HILCORP ENERGY COMPANY NAVAJO TRIBAL H 12 P&A NOI

Notice of Intent - Plug and Abandonment

Well(s): Navajo Tribal H 12, US Well # 30-045-08363 Location: Sec 14 T29N R14W (San Juan County, NM)

Sundry Notice ID #: 2863385

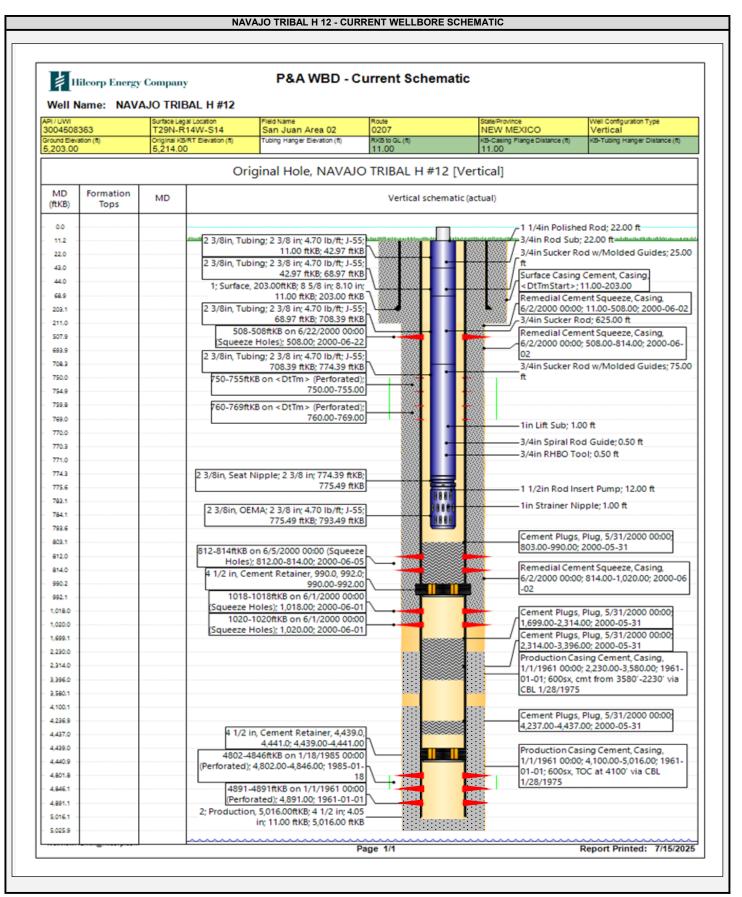
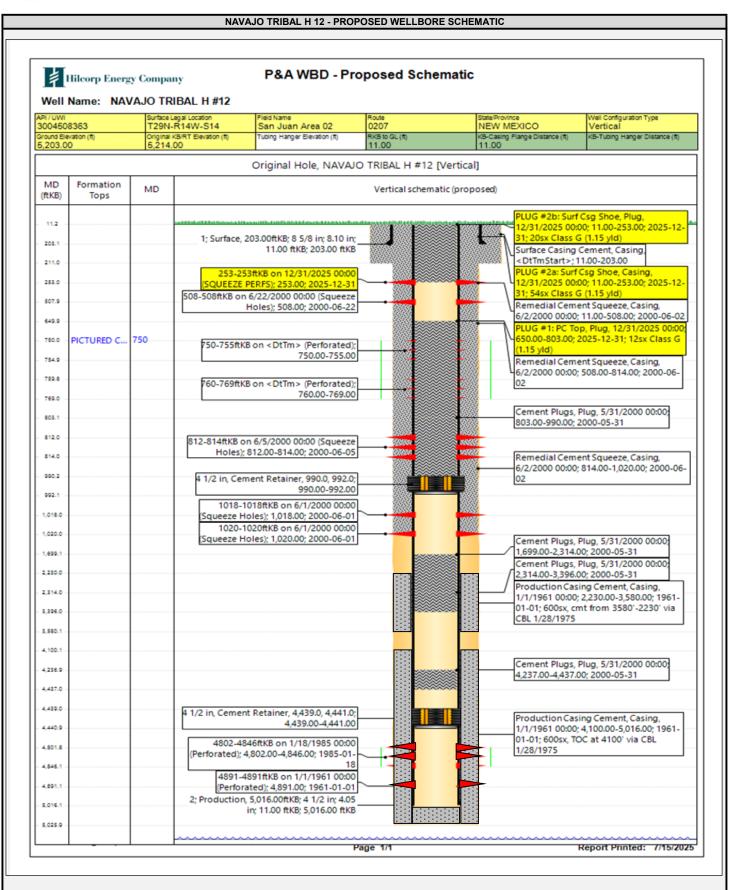
- 1. Plugging operations authorized are subject to the attached "General Requirements for Permanent Abandonment of Wells on Federal and Indian Lease."
- 2. The following modifications to your plugging program are to be made:
 - a. Modify Plug 1: Move the TOC to 450' to cover the BLM geologist's pick for Fruitland at 550'.
 - b. Modify Plug 2: Move the BOC to 400' to cover the BLM geologist's pick for Kirtland at 350'.
- 3. Notification: Farmington Office is to be notified at least 24 hours before the plugging operations commence at (505) 564 7750.

-Vertical wellbore, all formation depths are TVD from KB at the wellhead.
-Modify Plug 1: Move the TOC to 450' to cover the BLM geologist's pick for the Fruitland.
